HISTORIC AND DESIGN REVIEW COMMISSION

Agenda Item No: 23

HDRC CASE NO: 2016-119
ADDRESS: 1921 FREDERICKSBURG RD
LEGAL DESCRIPTION: NCB 6692 BLK 1 LOT N W 108.2 FEET OF 1
ZONING: C2NA H
CITY COUNCIL DIST.: 7
DISTRICT: Monticello Park Historic District
APPLICANT: David Komet/1921 Deco Building LLC
OWNER: David Komet/1921 Deco Building LLC
TYPE OF WORK: New Construction and signage
REQUEST:

San Antonio Historic and Design Review Commission
Conceptual Design Review
1921 Fredericksburg Road

SHEET:
A-1
SITE PLAN

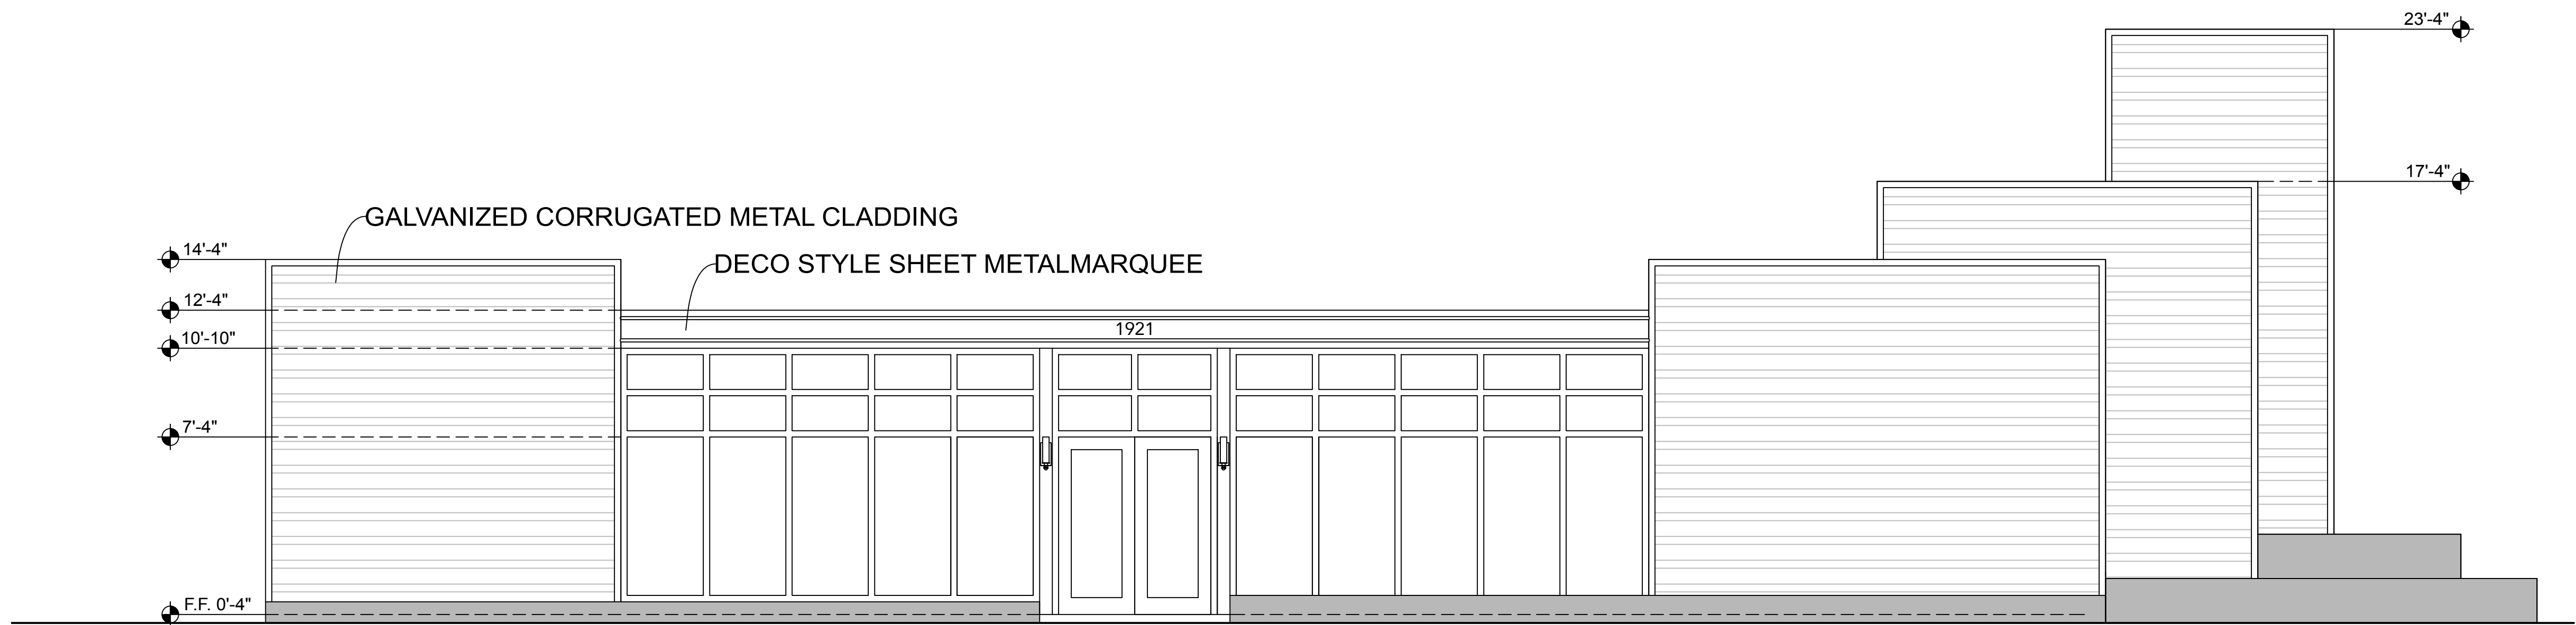
- e. Commercial structures found along the Fredericksburg Rd commercial corridor, all generally feature a common orientation, fronting the street and angular corners, with a setback that is consistent with the structures sited on adjacent properties. The applicant is proposing to orient the building to front Fredericksburg Road but not to front Elmendorf Street. According to the Guidelines for New Construction 1.A., the front façade orientation should be consistent with historic buildings along the street frontage. Staff finds the proposed footprint and orientation is a missed opportunity to take advantage of a uniquely shaped and placed lot. Staff finds that the applicant should continue the building around the corner and address both Fredericksburg Road and Elmendorf Street. Changing the footprint to have some street presence on Elmendorf would be done without impact to the overall site plan.

- l. In regards to off-street parking, the Guidelines for Site Elements 7.A. state that parking areas should be placed at the rear of the site, behind primary structures. The applicant is proposing to place 5 parking spaces behind the new construction, with access from Elmendorf St. This is consistent with the Guidelines.

- m. In regards to landscaping, the Guidelines for Site Elements 6., state that streetscape elements should be consistent and continuous along the street. The applicant is proposing to plant four trees to shade the western façade and parking lot, install 6 rounded planters along the storefront, install a two-tier rounded planter bed at the street intersection, and install sod. The applicant has not provided details of plant materials. Staff recommends that the applicant provide details of plant materials before returning to HDRC for final approval.

- i. That the applicant enhances the street presence of the building on Elmendorf Street.
- ii. That the applicant explores the functional use of the corner element.
- iii. That the applicant provides further lighting details and landscape details before returning to the HDRC for final approval.

SHEET:
A-3
ELEVATIONS

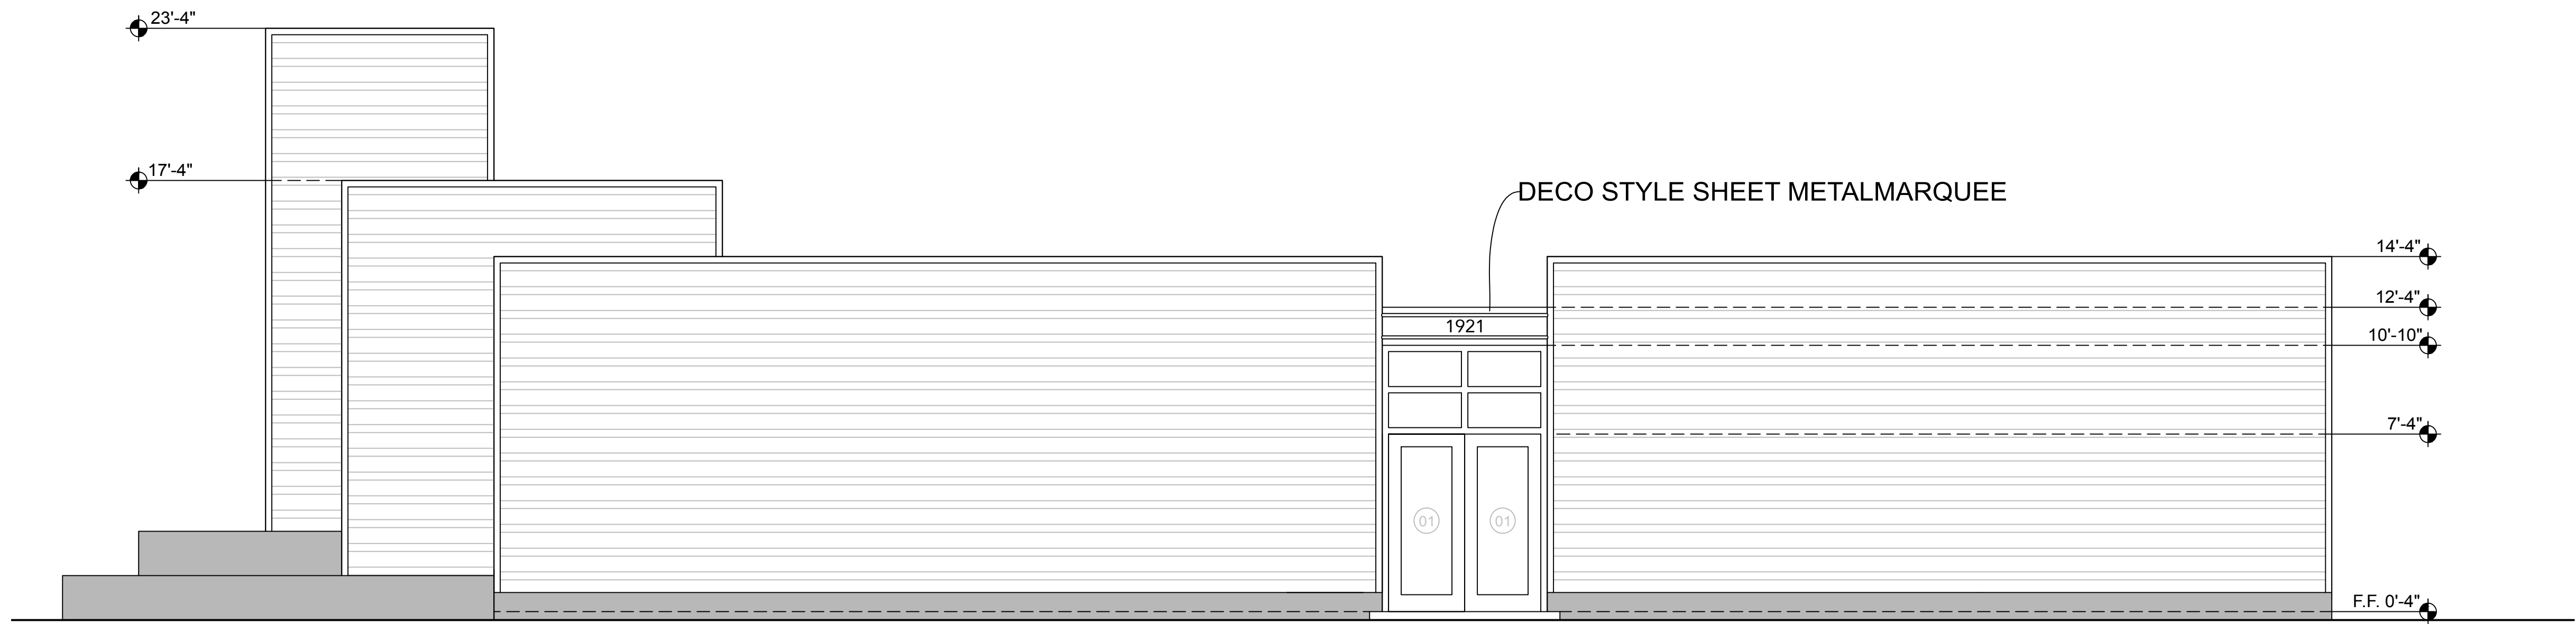
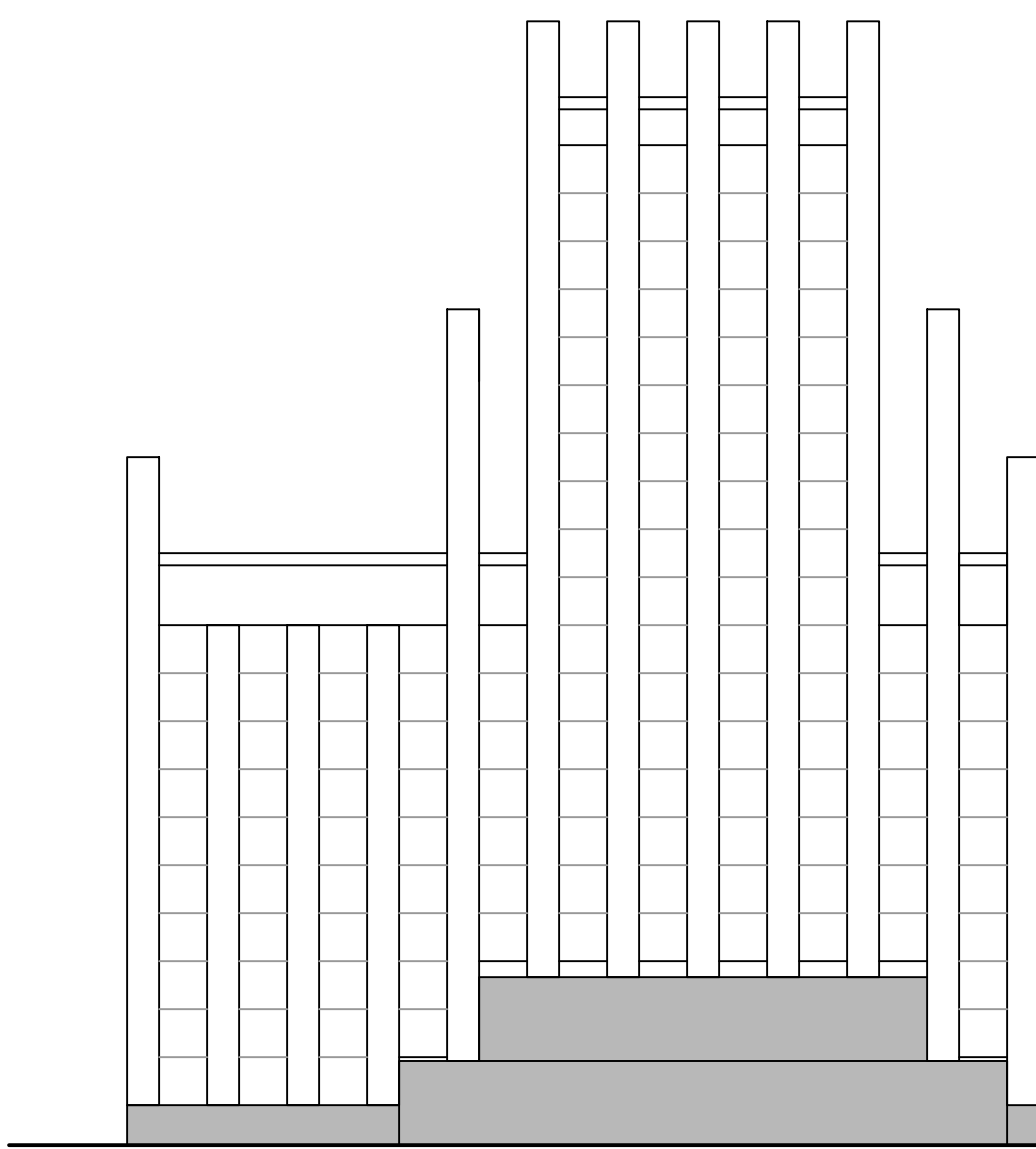
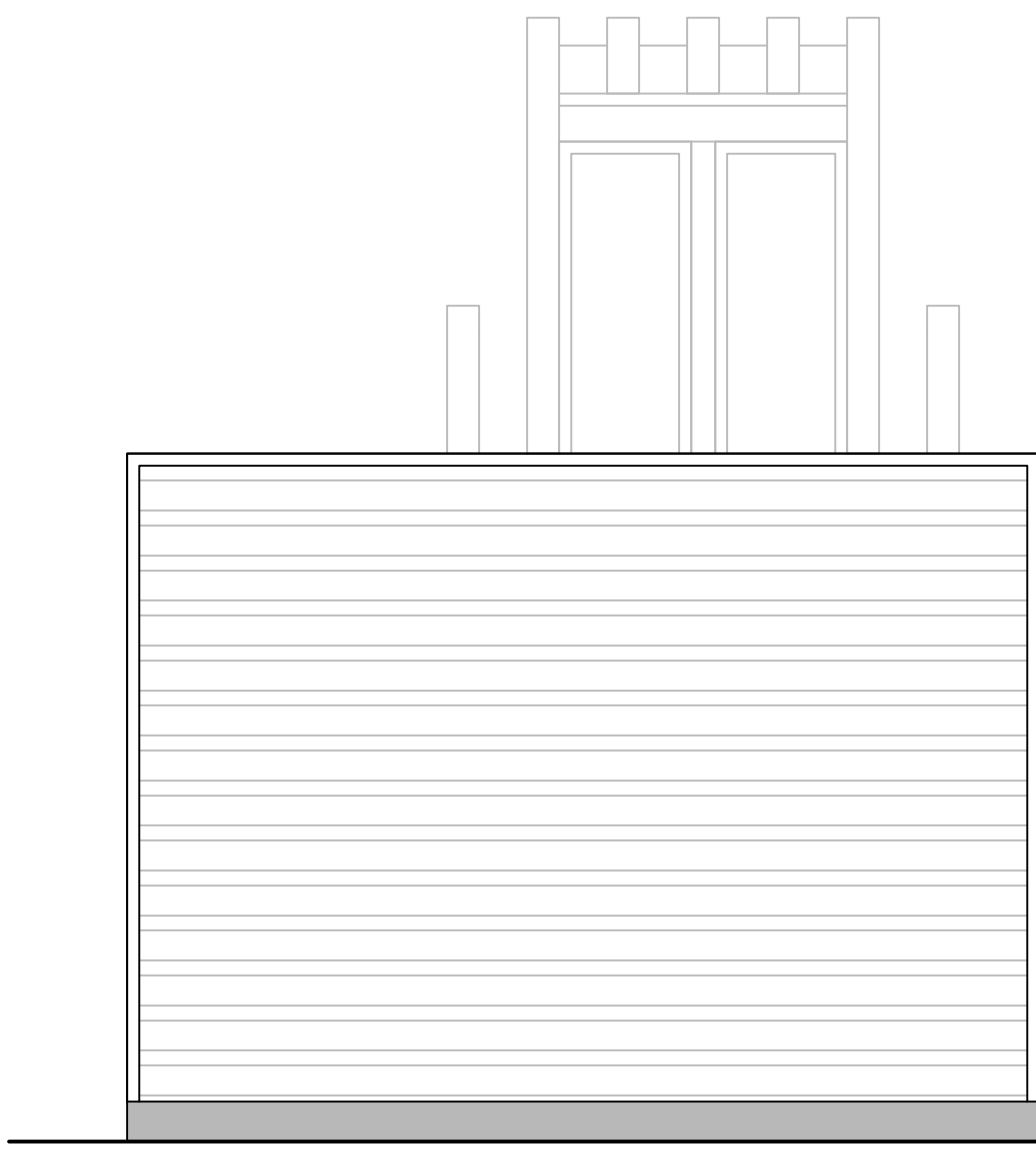
- d. The applicant is proposing to build a one story building with a 24' prow at the corner of the building nearest the intersection. According to the Guidelines for New Construction 2.A., new construction in historic districts should feature a similar height and scale as the surrounding structures. Staff made a site visit on March 28, 2016, and found that the surrounding properties on Fredericksburg Road are typically one stories. The applicant's proposed height is consistent with the Guidelines.

- g. The applicant is proposing that the new building have a floor to ceiling storefront along Fredericksburg Road, a glass rear double door, and ribbons of glass block between the wall planes on the corner façade. According to the Guidelines for New Construction 2.C.ii., blank walls should be avoided on elevations that face the street and new construction should feature window and door openings with a similar proportion of wall to window space as

- j. According to the Guidelines for New Construction 4.A.ii., architectural details that are in keeping with the predominant architectural style. The applicant is proposing an office building with black tiles at the base of the building, with a marquee awning covered in sheet metal, and featuring a prow consisting of 10 vertical fins separated by glass blocks. Staff finds the tile base and marquee awning consistent with the art deco architectural style.

MG: How will resolve clamp over edge w siding? Take trim over the top? color? (lighter color) not reflective. not charcoal.
